PART OF THE SOUTHEAST 1/4 OF SECTION 11, TOWNSHIP 15 SOUTH, RANGE 66
 WEST OF THE SIXTH PRINCIPAL MERIDIAN,
 COUNTY OF EL PASO, STATE OF COLORADO
MAJOR SITE DEVELOPMENT PLAN

2232 - EL PASO, COLORADO
 SECURITY BLVD. AND MAIN ST.
GRADING PLAN

MAJOR SITE DEVELOPMENT PLAN

1 LANDSCAPE PLAN

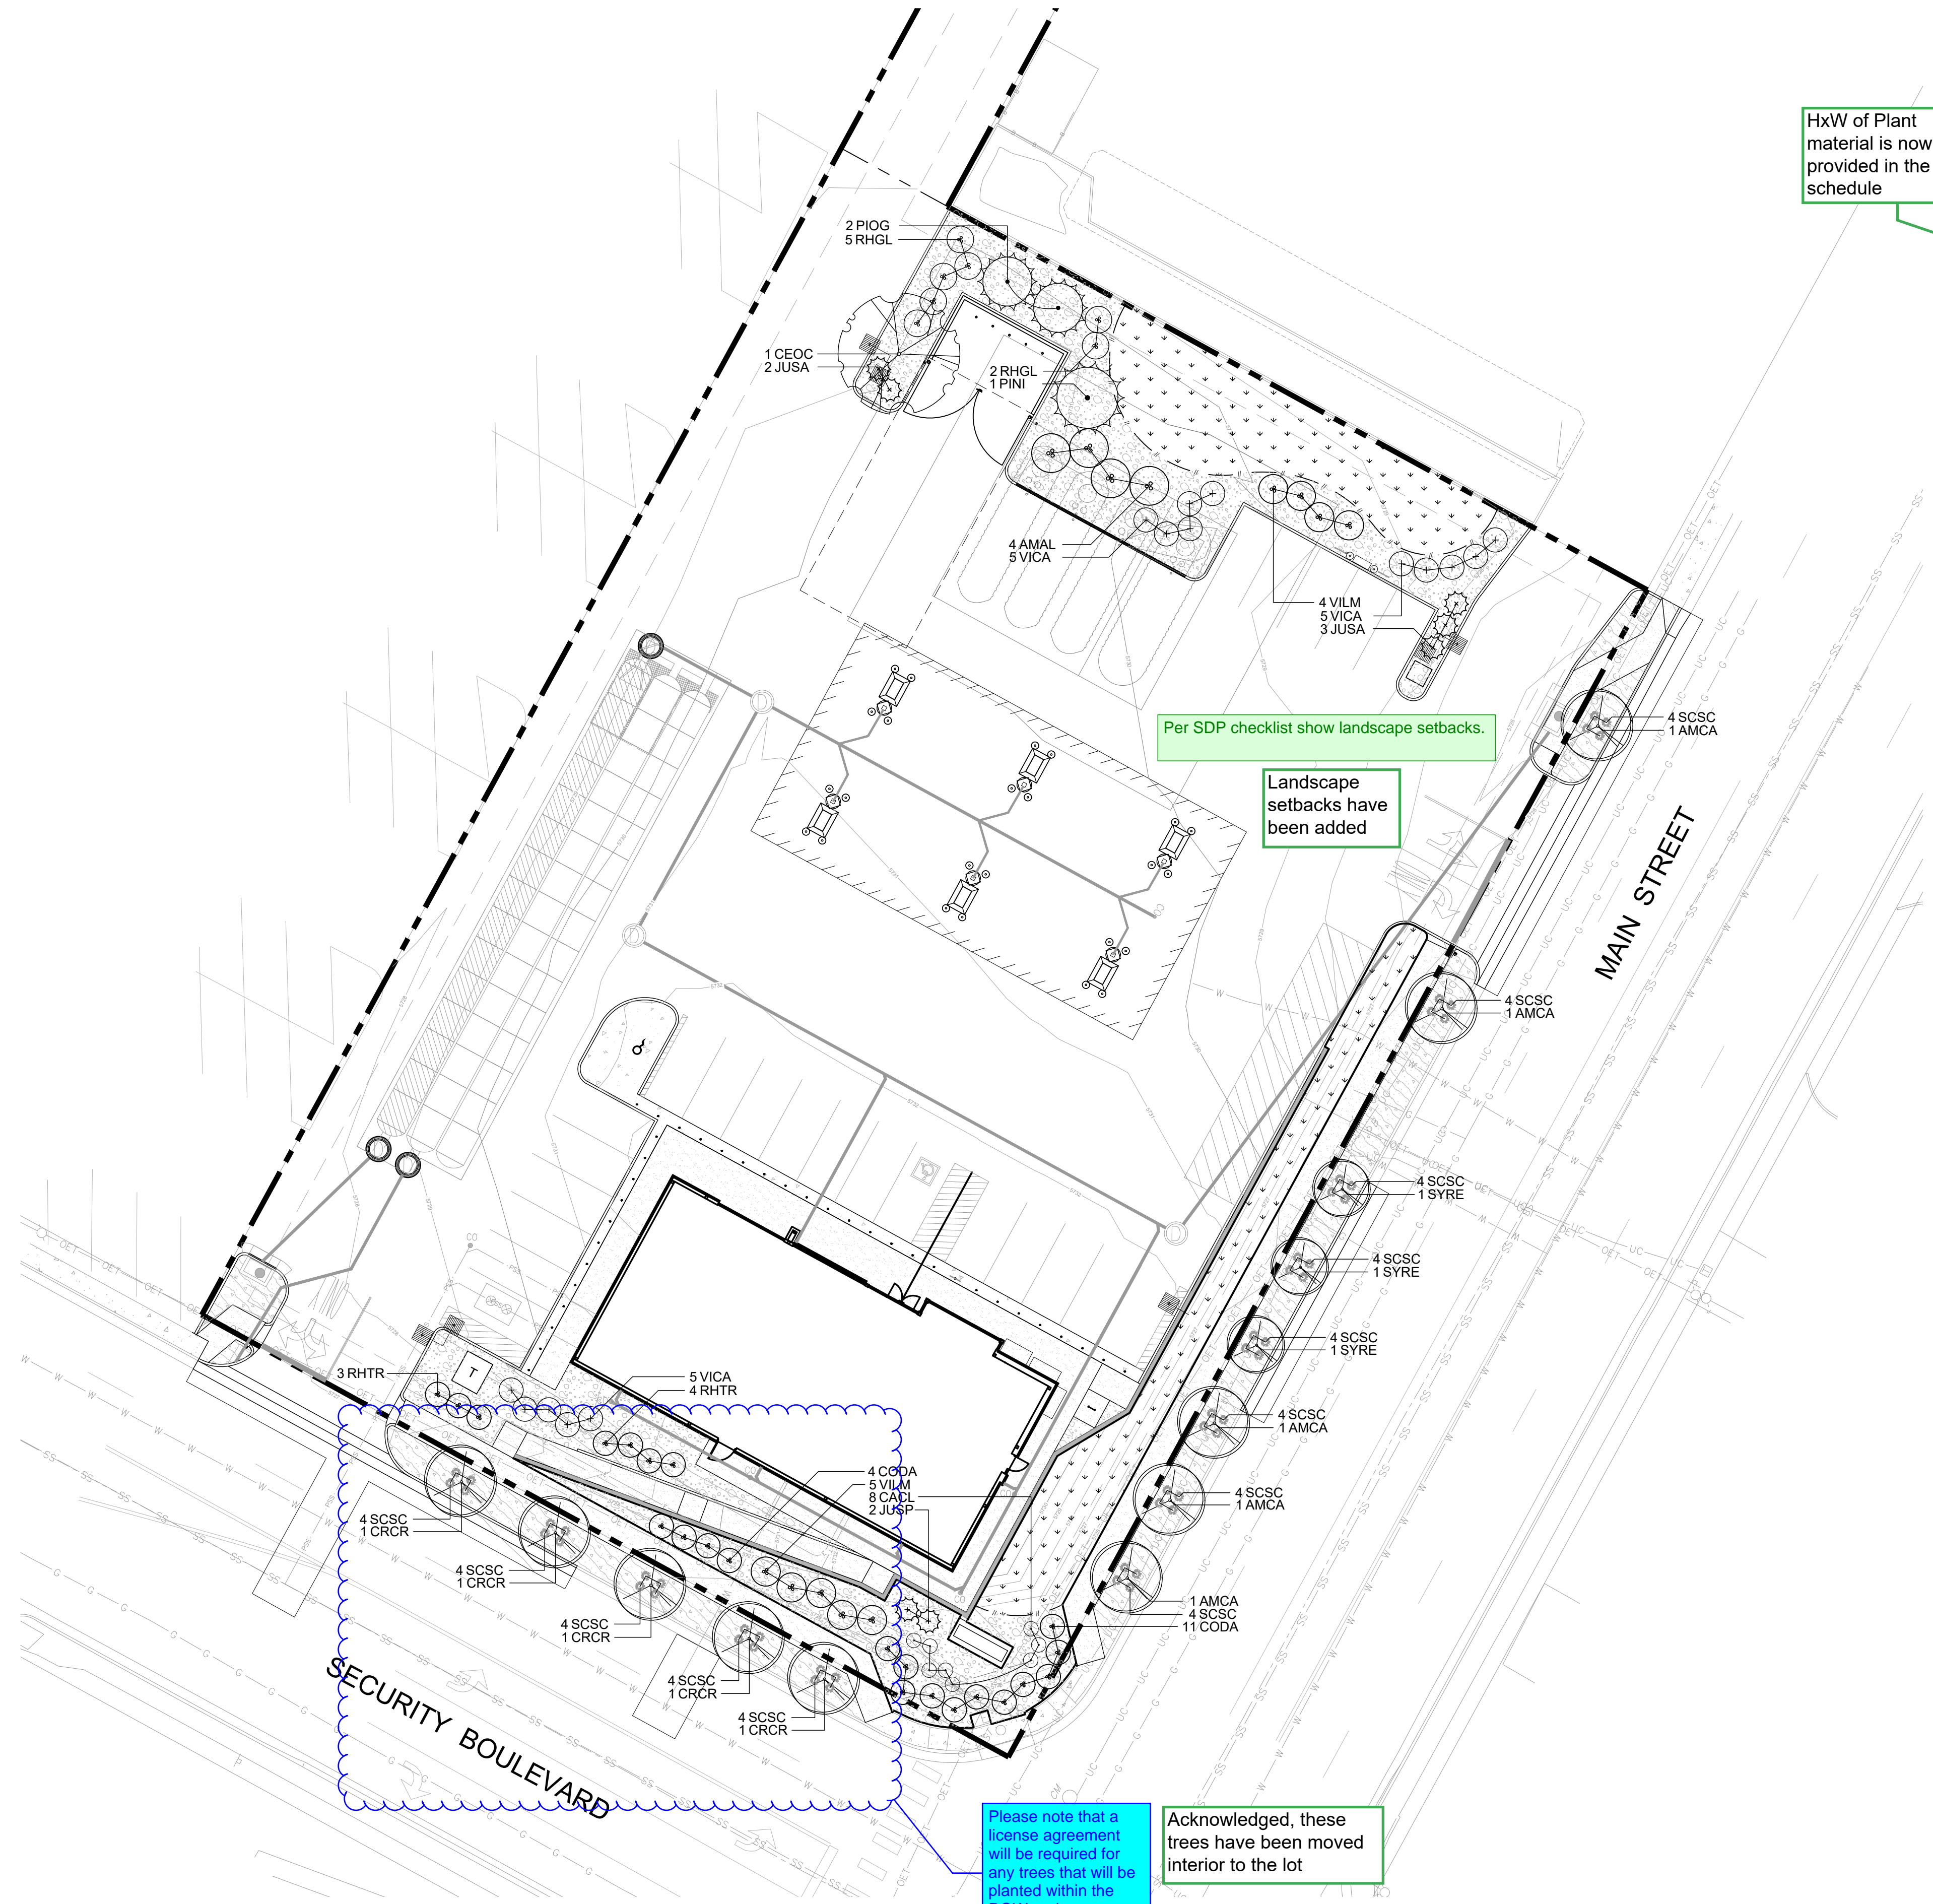
Please note that a license agreement will be required for any trees that will be planted within the ROW and can grow over the travel lane.

Per SDP checklist show landscape setbacks.

Acknowledged, these trees have been moved interior to the lot

Landscape setbacks have been added

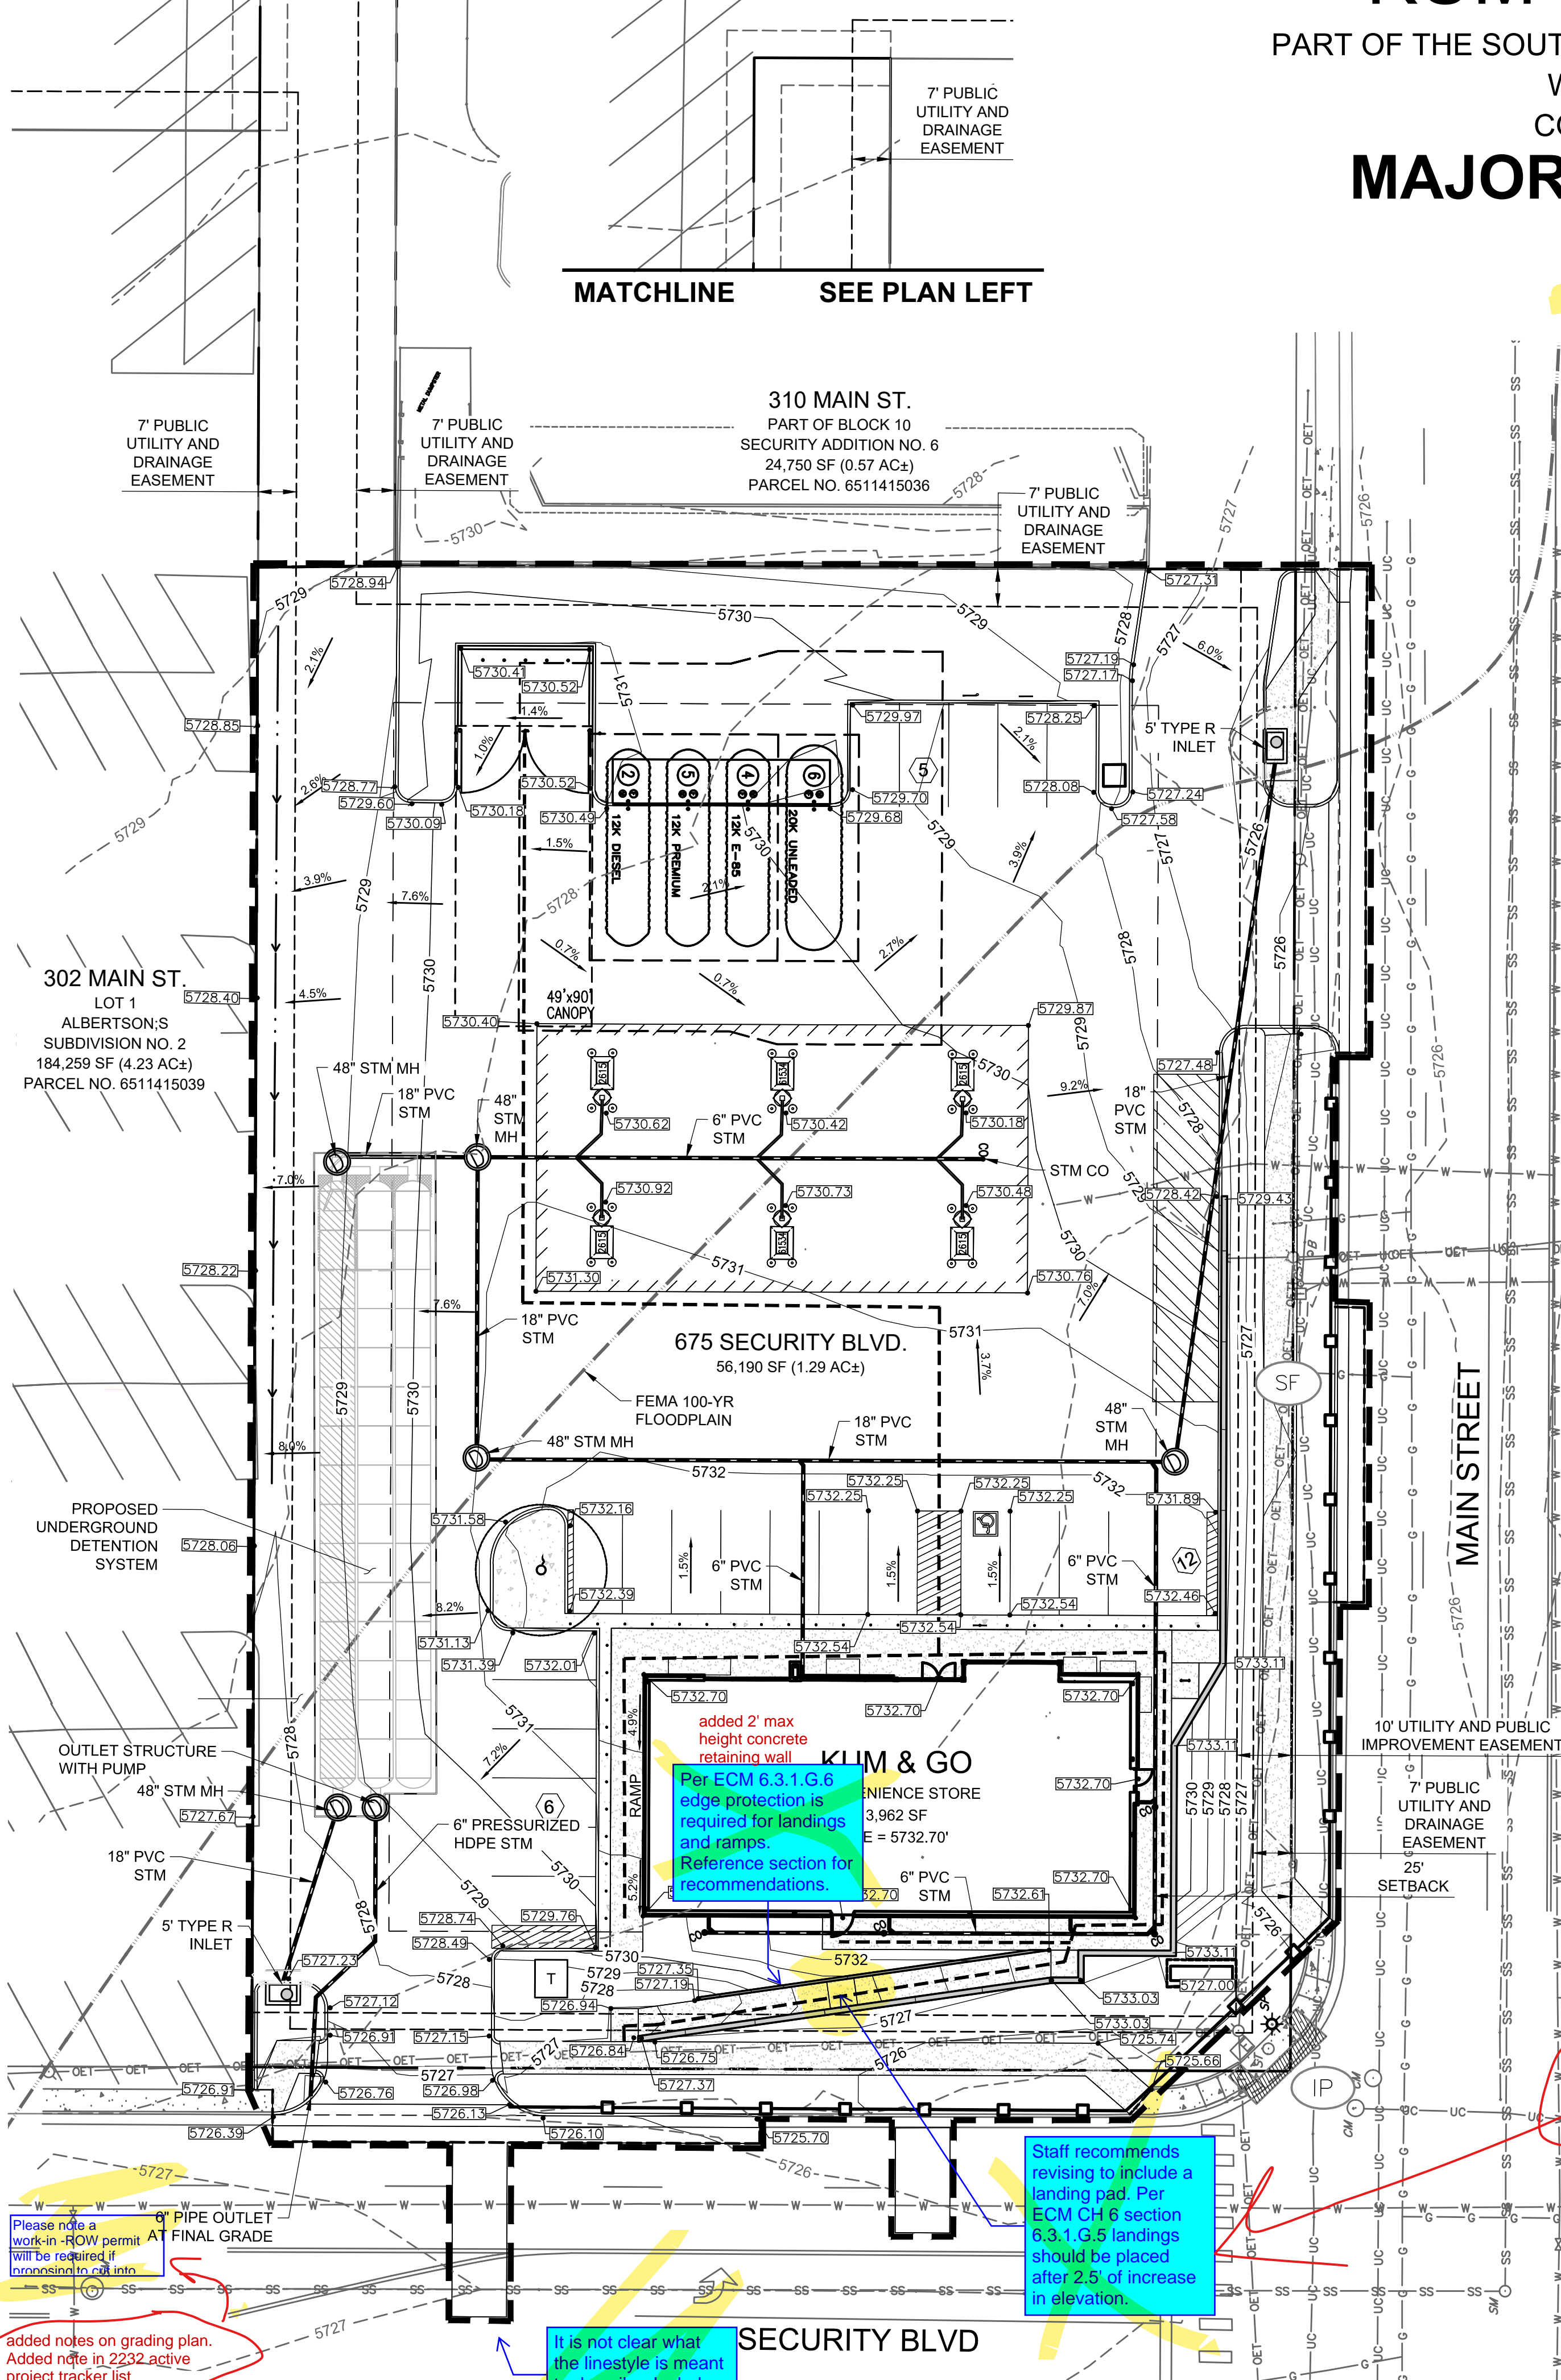
Please provide construction details for underground water quality pond. The details can be shown in these plans or in separate construction drawings. Show outlet structure pipe inverts and elevations of pond. Also include invert elevation of inlet at the intersection of Main and Security that is the outfall for the project.

It is not clear what the linestyle is meant to describe. include in legend.

Added ADS details on sheet 13.

Added "Storm Sewer Plan" showing outlet structure pipe inverts. Added Label with Pipe Elevations for Existing Inlet at NW corner of intersection where new storm drain pipe connects.

landing included with this design just not labeled appropriately. spot els and label added.
